# Project 4: Shift Wastewater Treatment of Canyon Flows to U.S. (via Expanded ITP or SBWRP) to Reduce Flows to SAB Creek

## Addendum to the Feasibility Analysis

### USMCA Mitigation of Contaminated Transboundary Flows Project

17 September 2021

Figure 2-1. Updated Overview of the Project 4 Conveyance System

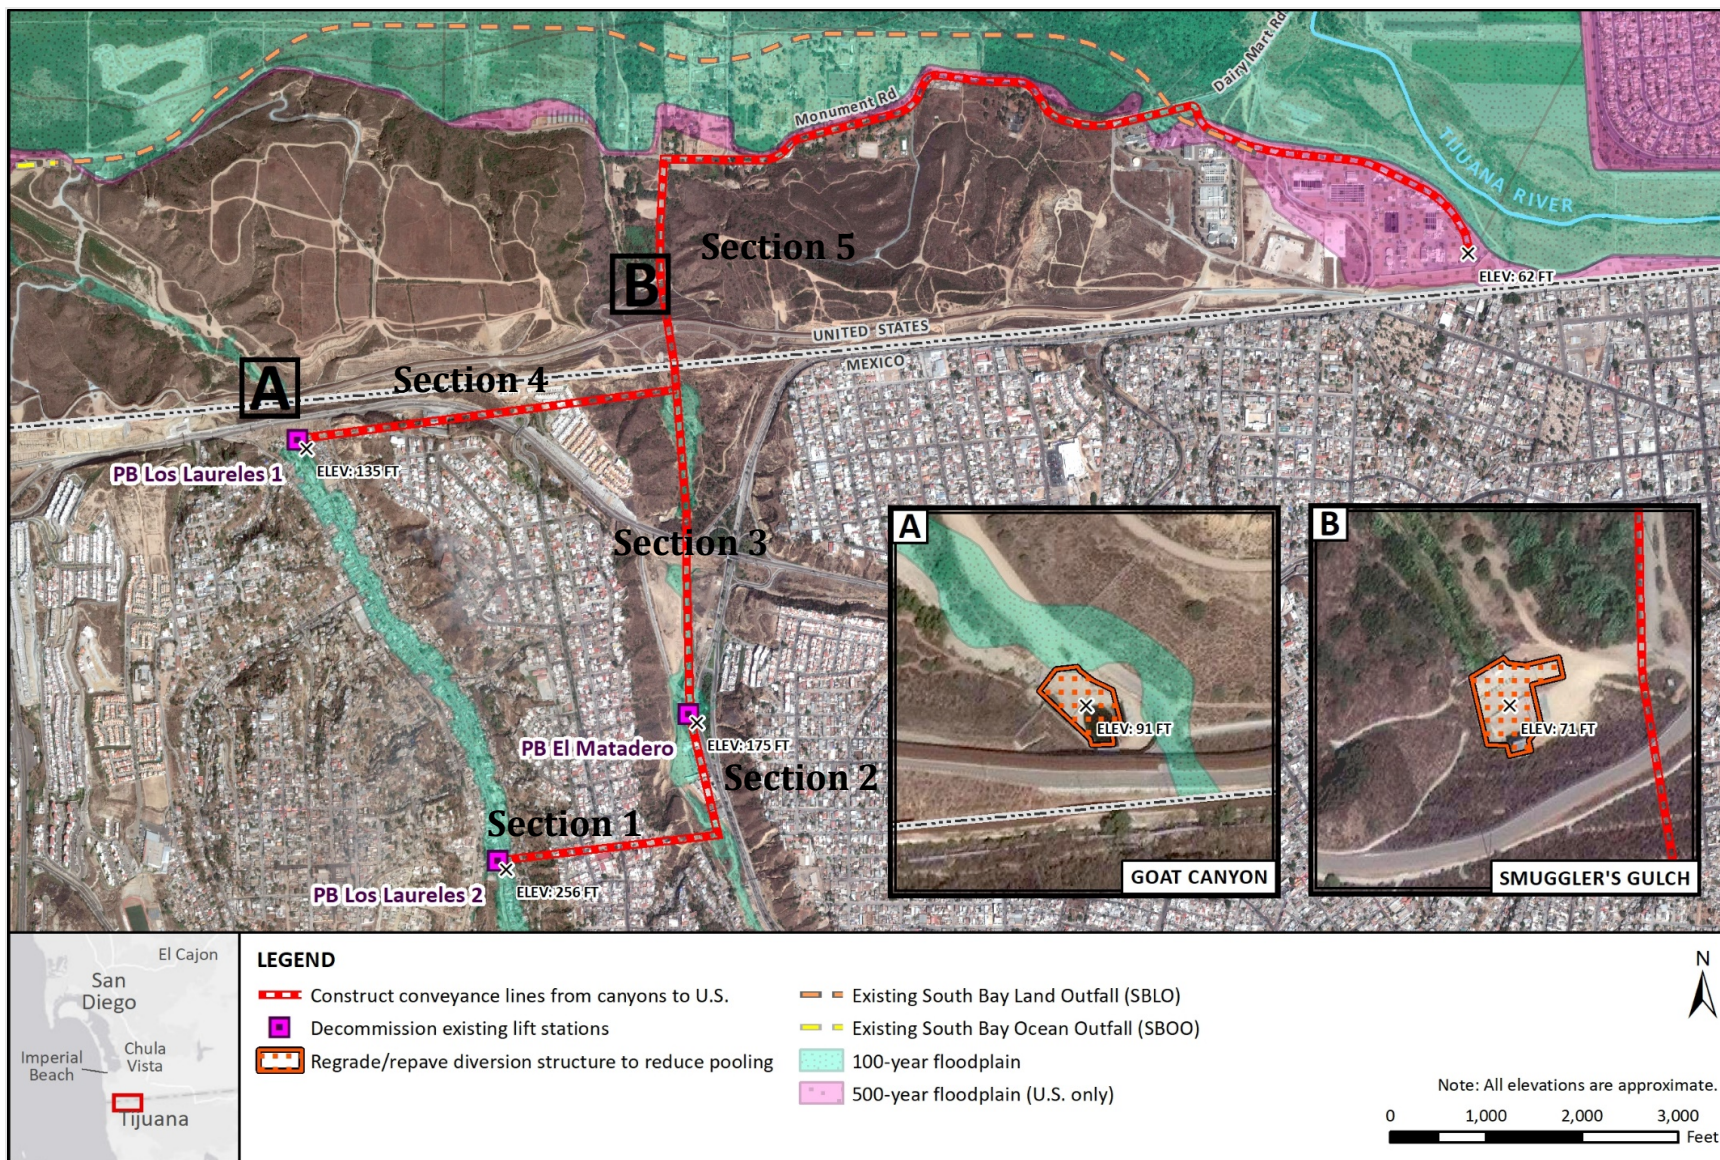
The design PG outlined in the Project 4 feasibility analysis consists of five sections of pipe, described in Section 2.1.1 of the feasibility analysis. As part of the alternatives analysis process, PG altered the route of Section 5 of the pipe to flow around the north side of the ITP to allow for easier and cheaper construction. The updated network of pipes is shown in Figure 2-1 on the next page.

PG updated the starting and ending elevations of Section 5 to reflect the elevation of the headworks for the ITP. PG made this update because treating the canyon flows at the South Bay Water Reclamation Plant (SBWRP) is no longer feasible, and because the International Boundary and Water Commission (IBWC) has provided new elevation information. PG determined the surface elevation of the ITP and the starting and ending points of each section of pipe using LiDAR data.

PG determined that Section 5 of the new conveyance line would operate under force main conditions due the pipe flowing uphill from Smuggler’s Gulch to the headworks of the ITP. The pressure gradient in Section 5 would be generated from the change in the pipe invert elevation from the beginning of Section 5 to Monument Road in Smuggler’s Gulch. PG used the Bernoulli equation to determine whether this pressure would be sufficient to overcome the frictional losses in the pipe during peak flow conditions. PG used the combined capacity of the three pump stations (12.7 MGD) as the anticipated peak flow rate. PG estimated the frictional losses from the pipe using the Darcy-Weisbach equation. The frictional losses were multiplied by 1.1 to account for additional losses from pipe fittings. PG determined that the 60 feet of head generated from the elevation change would be sufficient to overcome the 57 feet of head loss due to friction. Since enough head is generated in Section 5 to convey the flows to the ITP, Sections 3 and 4 would now operate as gravity lines.

PG adjusted the characteristics of Section 3 to reflect that it would flow by gravity rather than force by changing the pipe used from 21-inch PVC to 18-inch HDPE. PG verified that the pipe in Sections 1–4 would be able to convey flows by gravity using Manning’s equation. PG evaluated the flow characteristics for each section at both ends of the expected range of flow rates shown in Table 2-2. PG assumed that plastic pipe has a Manning’s roughness coefficient of 0.11.
